**MIAMI DADE TRANST – OFFICE OF CIVIL RIGHTS AND LABOR RELATIONS
FTA KEY STATION 2003 ASSESSMENT FINDINGS FROM EXIT CONFERENCE
SUMMARY AS OF DECEMBER 2005**

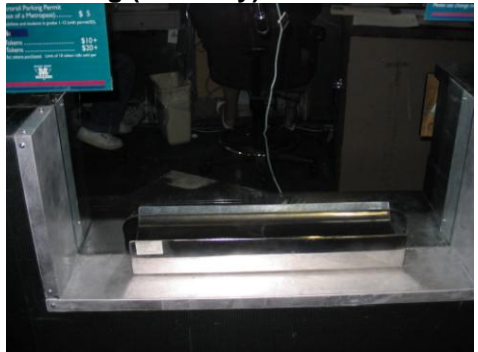
BRICKELL DECEMBER 2003 ASSESSMENT	FINDINGS	CORRECTIVE ACTION	EXHIBITS	DATE ITEM CURED
	Response: The newspaper vending box will be relocated.			
ELEVATORS	<p>Elevator (1) – North End Previous Finding: There are no vision panels at the street level of the north elevator. The deficiency remains, as shown in Exhibit 3-40.</p> <p>Response: Vision panels will be provided at the street level of the north elevator.</p>	Vision panels were installed at the street level of the north elevator as shown in Exhibit 3-40.	<p>Exhibit 3-40 – North Elevator – Street Level – Vision Panels</p> 	3/31/05
	Previous findings: The hall call buttons do not light and the hall lantern does not light on the north elevator.	The hall call buttons lights and the hall lanterns have been replaced, as shown in Exhibit 3-40(a)	Exhibit 3-40(a) – North Elevator – Hall Lanterns	11/4/04

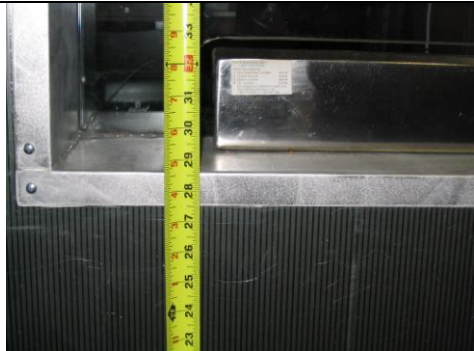
BRICKELL DECEMBER 2003 ASSESSMENT	FINDINGS	CORRECTIVE ACTION	EXHIBITS	DATE ITEM CURED
	Response: The hall call buttons and the hall lanterns will be replaced.			
	<i>Previous findings: There is no Braille below the raised floor designations on the hoistway jambs of the north elevator.</i> The deficiency has been corrected.			
	Previous findings: The floor buttons on the north elevator's control panel do not light. The deficiency has been corrected.	The floor buttons on the control panel are functional.		
	<i>Previous findings: There are not audible signals on the north elevator car position indicator and characters are ¼ inch high.</i> The deficiency has been corrected.	All the audible signals are functional.

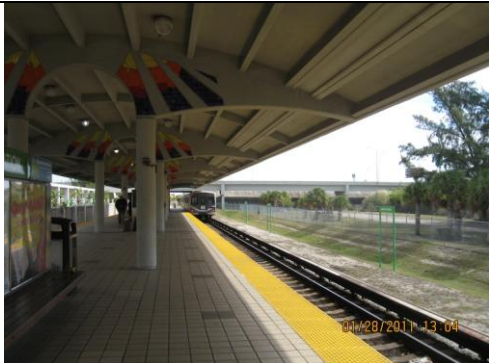
TRI-RAIL DECEMBER 2003 ASSESSMENT	FINDINGS	CORRECTIVE ACTION	EXHIBITS	DATE ITEM CURED
ACCESSIBLE ROUTE	<p>Previous finding: the most direct route from the bus stop at 79th Street and 11th Avenue is along 11th Avenue which is not accessible (no sidewalk). The</p>	<p>An accessible route has been constructed to connect the station accessible entrance to the streets and bus stops located across the</p>	Exhibit 3-23(a) Accessible walkway	6/15/05
